- 1. Comment letters received
- 2. Meeting Minutes from September 18, 2019 joint board meeting of the three GSA Boards

Subject: Comments on the Merced Subbasin Draft Groundwater Sustainability Plan

Figure 1 - Representative Monitoring Network for GW Levels Relative to Domestic Wells, DACs, and Community Water Systems Merced Subbasin

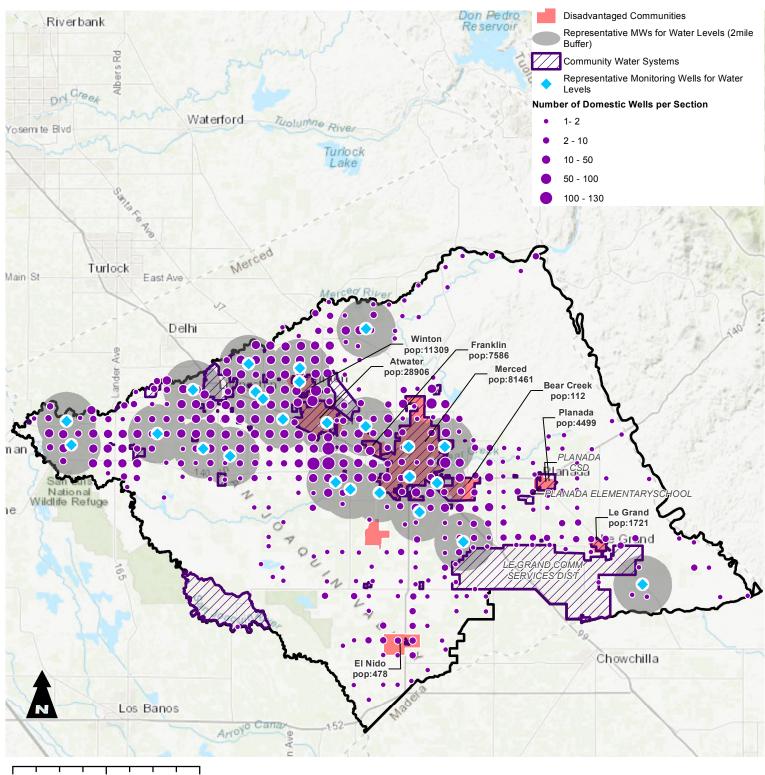
- Given the limited spatial distribution of the RMW network, a substantial proportion of domestic wells within the subbasin appear to have not been considered in the development of these MTs.
 Figure 1 shows the location of domestic wells within the subbasin. Each dot is scaled to represent the number of wells located within a given PLSS Section (i.e., approximately a 1-square mile grid cell). Based on this assessment, approximately 1,100 out of approximately 3,600 domestic wells in the subbasin are located outside of the two-mile radius areas used to establish these MTs. Nearly one-third of all domestic wells in the subbasin were therefore not considered in the establishment of MTs.

- The RMWs are generally located in the center of the subbasin, while domestic wells are distributed widely across the subbasin. In particular, as shown in **Figure 1**, the domestic wells located in and around the DACs of El Nido, Planada, Le Grand, and south of the City of Merced are located outside of the areas being monitored for water levels. As such, there are no water level RMWs, or SGMA compliance points, for water levels in the vicinity of these beneficial users.

- Figure 1 also shows the location of community water systems in the subbasin. As you can see in this figure, the RMW network does not provide adequate coverage for the Planada Community Services District (CSD), Planada Elementary School, or Le Grand CSD; combined, these systems serve a population of over 6,800 people.

Figure 2 - Water Level MTs and Domestic Wells Merced Subbasin

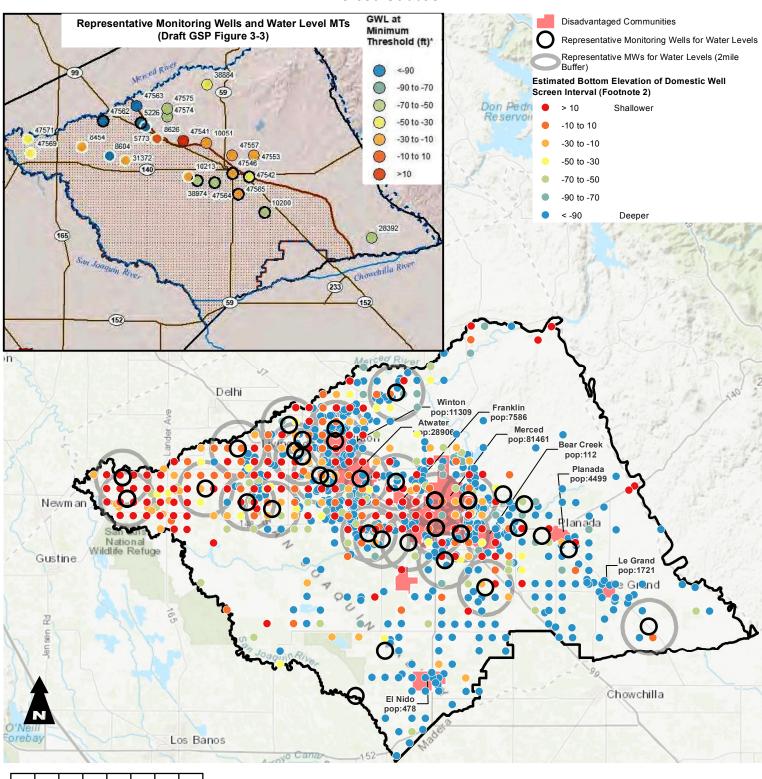
- **Figure 2** shows the approximate elevations of the domestic well depths (as estimated elevations) with an inset of Figure 3-3 from the draft GSP, which presents the groundwater levels at the proposed MTs for the RMW network. Domestic well depths are shown using the same color

Figure 3 - Representative Monitoring Network for Water Quality Relative to **Domestic Wells, DACs, and Community Water Systems** Merced Subbasin

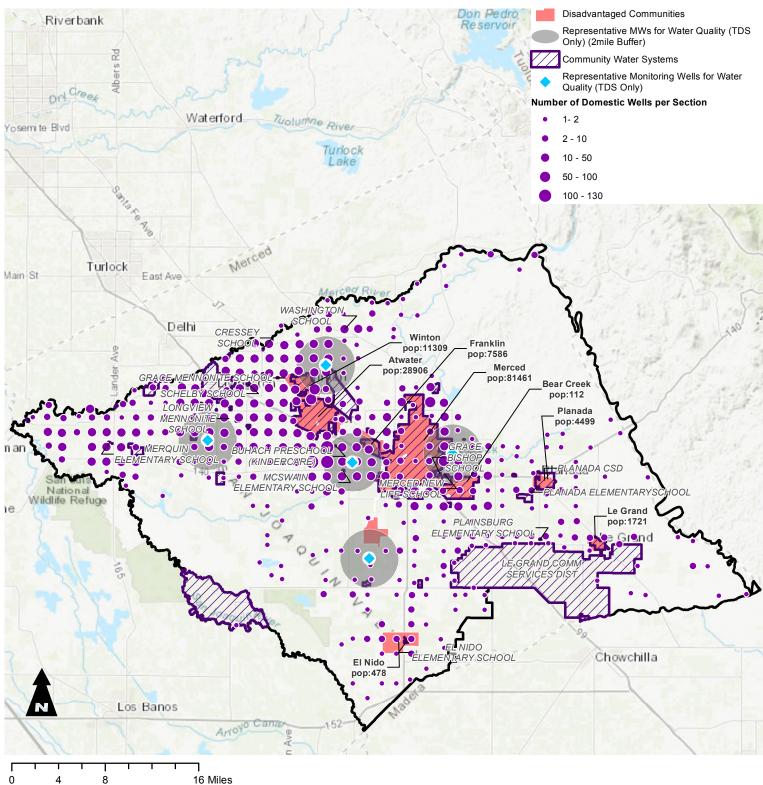
- Figure 3 shows the location of domestic wells within the subbasin. Each dot is scaled to represent the number of wells located within a given PLSS Section (i.e., approximately a 1-square mile grid cell). Figure 3 also shows the location of the five water quality RMWs. Over 2,600 out of 3,600 domestic wells in the subbasin are located outside of a two-mile radius of these RMWs. Over 70% of all domestic wells in the subbasin are therefore located more than two miles from RMW locations where water quality sustainability will be evaluated against MTs.

- As shown in **Figure 3**, nearly 70 community water systems are located in the subbasin, most of which are located far from the water quality RMWs, including Planada CSD, Le Grand CSD, and many systems supplying schools in the area. The proposed water quality representative monitoring network appears to be inadequate for measuring and quantifying the sustainability of
